Retaining Plate Part No. 3006241

No. 01 / 2022

1) Retaining plate for FW24-H-T series

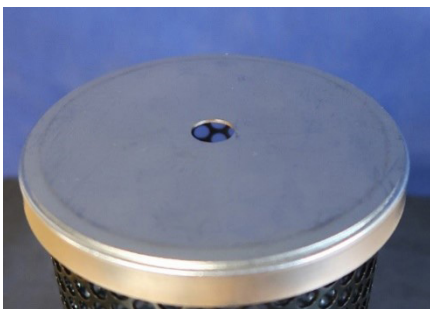
Cases of damaged retaining plates have been reported, used to seal against the separator end cap and mounting rod in filter water separators model FW24-H-T.

Retaining plates are polyphthalamide (PPA) and tested to a tightening torque of 30 Nm.

b. End cap deformation up to 3mm, either reuse the existing separators and replace the PPA retaining plates with aluminium versions, available from FAUDI Aviation or the local distributor, or purchase replacement separators and new retainer plates in PPA or aluminium.

Over-Torqued Example From The Field

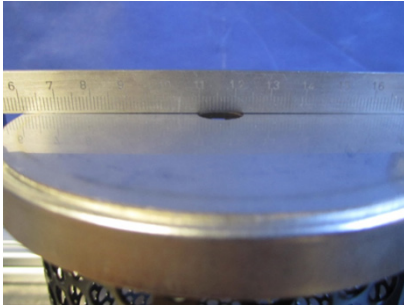
Where damaged retaining plates were found, indentations in the stainless steel end cap of the separator elements were observed, indicating over-tightening of the hex nut which secures the element.

The following series of images shows the degree of indentation at a given torque.

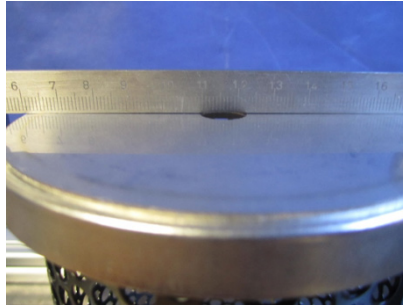
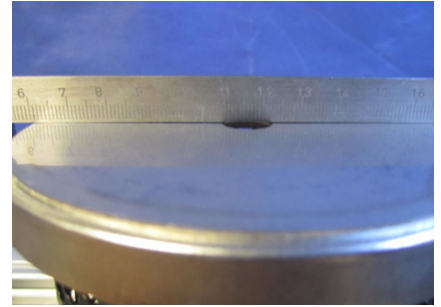
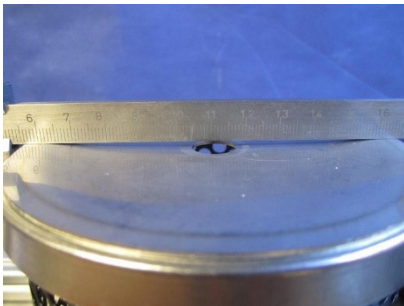
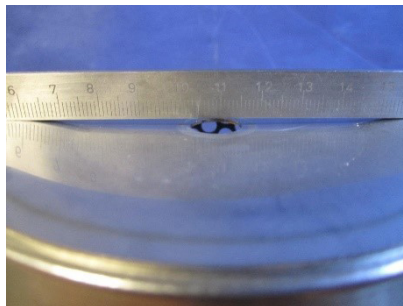
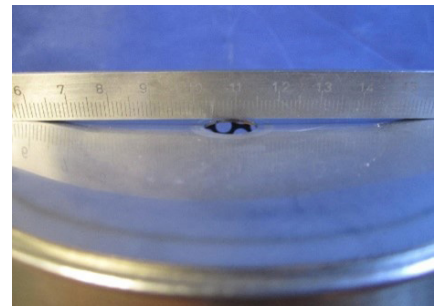
Following in-house testing to reproduce the indentations, it was determined that the hex nut had been over-tightened.

It has been determined that once the end cap has deformed, that loading on the retaining plate is distributed around the outer edge of the plate, rather than the flat surface on a flat end cap, as designed. The result is that after replacing a broken polyphthalamide retaining plate, with another in polyphthalamide (PPA), the torque that it is capable of withstanding is reduced.

a. End cap deformation of less than 1.5mm and the existing PPA retaining plate intact, both the separator and retaining plate may be re-used.

c. End cap deformation over 3mm, purchase replacement separators and retainer plates in PPA or aluminium. 7 Nm remains the recommended torque in either material.
